ASSESSMENT REPORT

Shoalhaven Starches Ethanol Expansion Project Alterations to Flour Mill Section 75W Modification - MP 06_0228 MOD 8

Figure 3 – External Modifications to Flour Mill

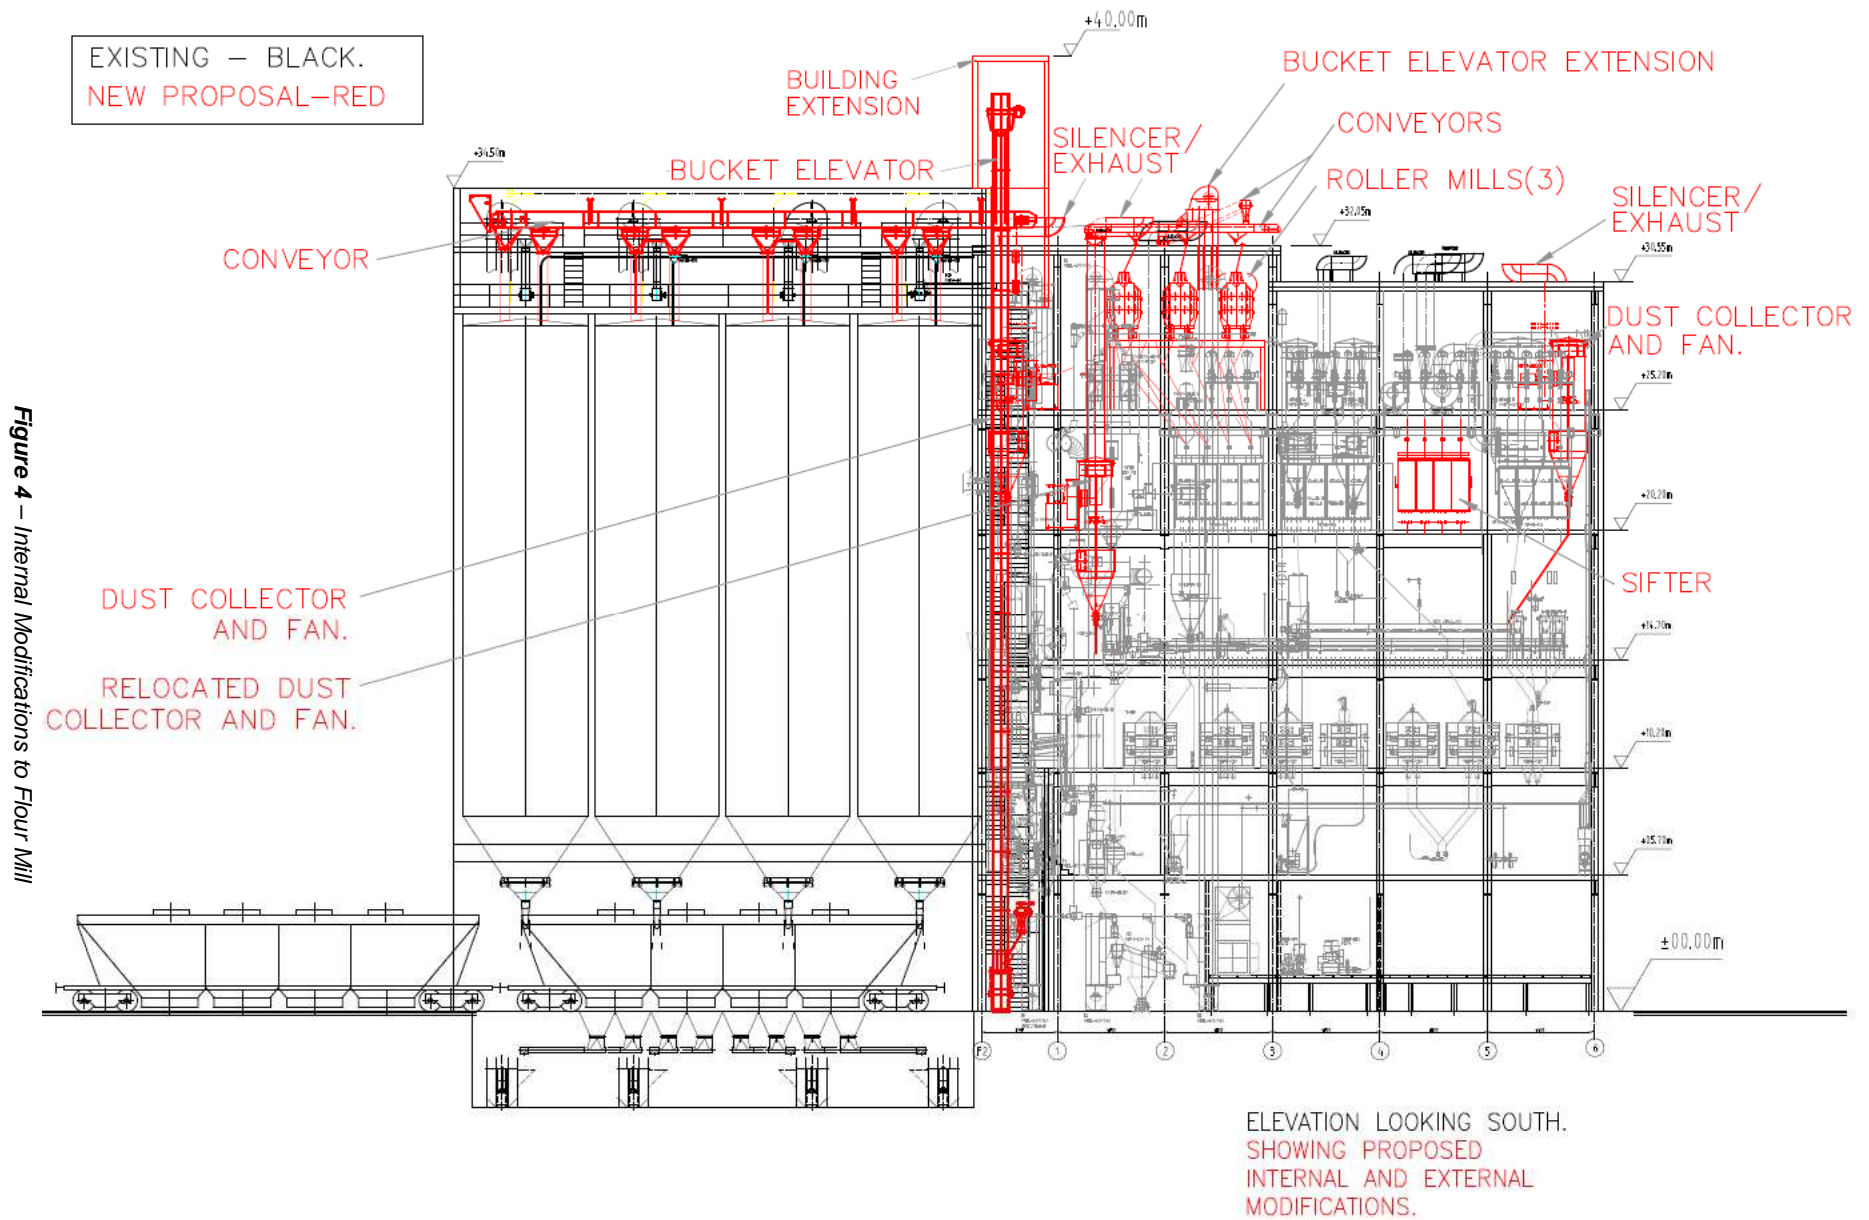
Visual amenity and building height	<p><u>Visual Amenity</u></p> <ul style="list-style-type: none"> • The modification would involve installation of additional equipment within the flour mill building, and additional plant located on top of the building. • External additions include extraction fans and silencers, a bucket elevator and conveyors. The building extension would extend to 40m high which is 5.5m higher than the adjacent silos and 8m higher than the top of the existing flour mill building. • The EA included a visual impact assessment which considered the visibility of the modified flour mill from key vantage points including Bolong Road to the north, Riverview Road and the village of Terara to the south and Nowra to the south-west. • The flour mill building is located adjacent to the riverbank and is generally shielded from view from Bolong Road by other factory buildings. Views from the south and south-west are over 1km away and hence the small additions to the flour mill building would not be visually prominent. • The proposed additions are also consistent with the existing industrial character of the factory site, of a similar height to other 	<ul style="list-style-type: none"> • Manage via existing conditions requiring the control of lighting and use of non-reflective building materials. • Require the Proponent to provide as-constructed details to Airservices Australia following completion of construction of the flour mill alterations.

Issue	Assessment	Recommendation
	<p>structures on site and consistent with other adjacent industrial premises on Bolong Road. Other higher structures on the site include the boiler stack at 54m, DDG stack at 49m and the No.6 dryer at 43m.</p> <ul style="list-style-type: none"> • Council did not raise any concerns regarding visual amenity and recommended the use of non-reflective building materials. • The Department's assessment concludes that the visual impacts of the proposed modification would be minimal given the scale of the existing industrial development on the site and that the additional structures would generally be of a similar appearance, height and bulk to the existing structures on the site. The Department considers that the visual impacts of the modification would be minor and would not require any specific conditions beyond the control of lighting, use of non-reflective building materials and landscaping requirements of the existing approval. <p><u>Tall Structures</u></p> <ul style="list-style-type: none"> • HMAS Albatross (airbase) is located 10km south-west of the factory. • The Proponent provided information to the Department of Defence regarding the height of the modified flour mill (40m). • The Department of Defence considered the potential impacts to the safety of aircraft operations from HMAS Albatross and advised that it had no concerns with the modification and that the modification would not infringe the Outer Horizontal Surface of the Obstruction Limitation Surface of HMAS Albatross. • The Department of Defence requested that the Proponent provide as-constructed details to Airservices Australia following completion of construction of the modified flour mill. • The Department has incorporated this recommendation into the modified conditions.

Plate 2: Rock revetment works adjacent to the flour mill

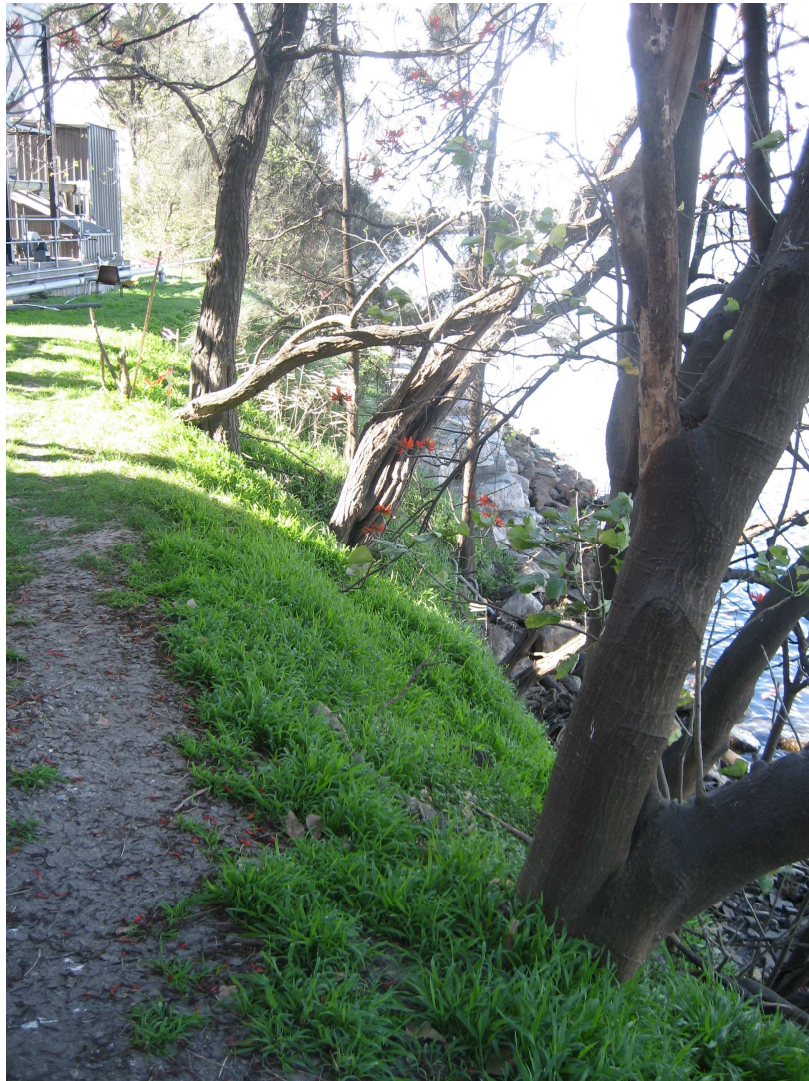
Coffey analysed the settlement and lateral movement of the rock wall and noted that since the 2009 data, there was a general downward movement at the top of the wall and general upward movement at the toe of the wall. Coffey noted that this movement could be due to the recent flood event, ground vibrations from piling works associated with construction of two silos near the flour mill and the accuracy of the survey.

Given the identified settlement and lateral movement, Coffey recommended that further, regular monitoring be carried out including:

- survey monitoring of the rock revetment wall every three months to assess whether there is an ongoing pattern of movement over the next 12 months;
- survey extending 15m from the toe of the revetment wall across the river bed to measure changes in the bed profile;
- regular visual observations to assess any obvious change to ground features, the effects of major rain events, flooding or any significant deepening or steepening of the river bed close to the revetment wall; and
- regular review of survey data and ongoing maintenance and repairs of the revetment wall.

The Department has considered the findings of the geotechnical assessment and concludes that the modification would not adversely impact on the stability of the riverbank but notes ongoing monitoring is required to ensure any changes due to high rainfall events are measured and appropriate maintenance can be implemented. The Department has recommended modified conditions requiring regular survey of the rock revetment wall and riverbank as recommended in the geotechnical assessment.
